ENGINE - FUEL AND CONTROL - TO PROVIDE A NEW ELECTRONIC ENGINE CONTROL (EEC) WITH THE
SCN11G/J SOFTWARE CONFIGURATION - CATEGORY CODE 8 - MOD.ENG-73-0027

V2500-ENG-73-0027

ENGINE FUEL AND CONTROL - EEC150-1 ELECTRONIC ENGINE CONTROL - INCORPORATION OF NEW SOFTWARE CONFIGURATION

Location of Electronic Engine Control (EEC)
Fig.1

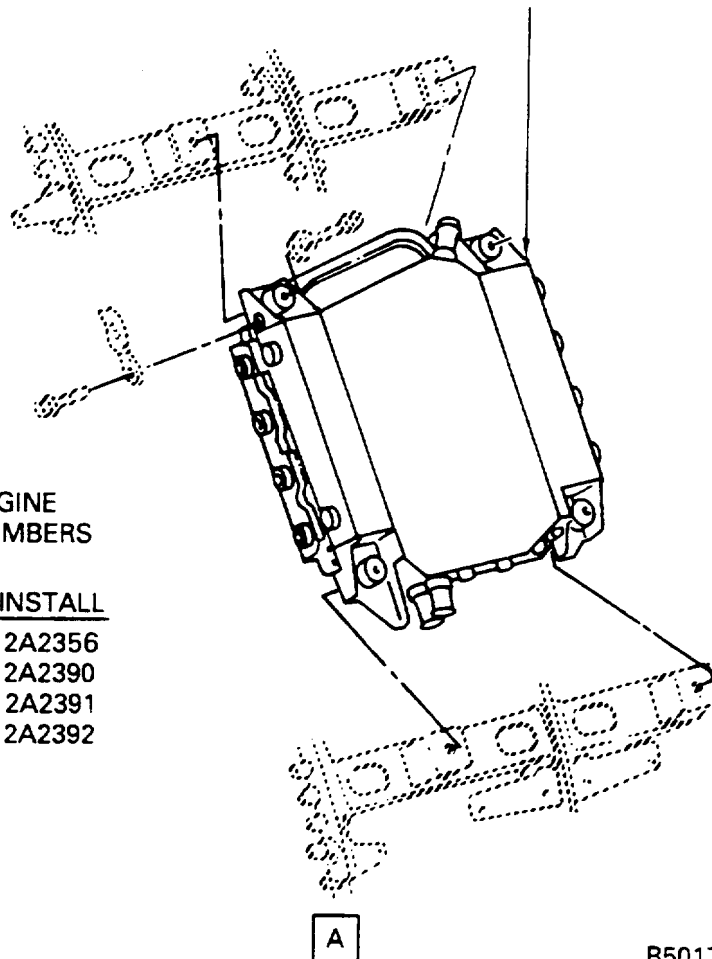
- (1) Disconnect the Data Entry Plug Assembly from the EEC. Use the IAE 1J12018 EEC Harness Wrench.
- (2) Remove the 2A2166, 2A21899, 2A2284 or 2A2285 Electronic Engine Control by the approved procedure in Reference (4), Chapter/Section 73-22-34, Removal/Installation. Refer to Figure 1.

REMOVE THE APPLICABLE PART NUMBER*
ELECTRONIC ENGINE CONTROL, DO A
MODIFICATION, IDENTIFY AND INSTALL
THE APPLICABLE PART NUMBER*

- (1) Install 2A2356, 2A2390, 2A2391 or 2A2392 Electronic Engine Control by the approved procedure in Reference (4), Chapter/Section 73-22-34, Removal/Installation by Figure 1 except as follows:
- (a) Connect the Data Entry Plug Assembly to the EEC.
- (b) Tighten and torque the Data Entry Plug Assembly to 32 lbfin (3,6 Nm). Use the IAE 1J12018 EEC Harness Wrench. See Reference (5), Chapter/Section 70-41-00, (TASK 70-41-00-400-501).

2A2189
2A2166
2A2284
2A2285

2A2356
2A2390
2A2391
2A2392
